# Planning & Zoning Commission

## UPPER METRO MIXED-USE BUILDING 23-121CP

23-121CP | Upper Metro Place Mixed-Use Building

Site Location Map

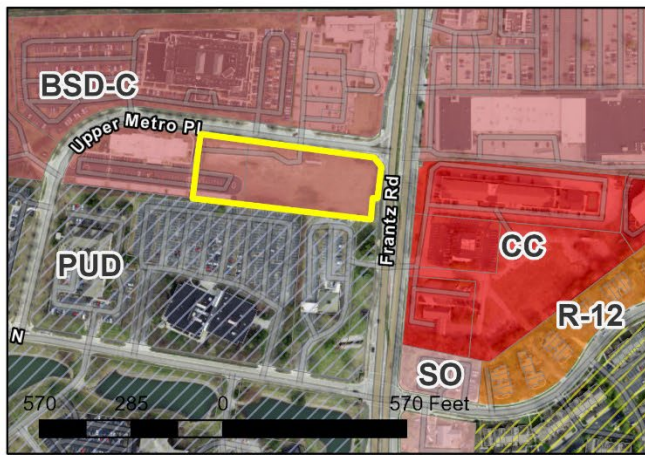
- Site Features**
- 1 Existing Parking Lot
  - 2 Stone Wall
  - 3 Tree Buffer
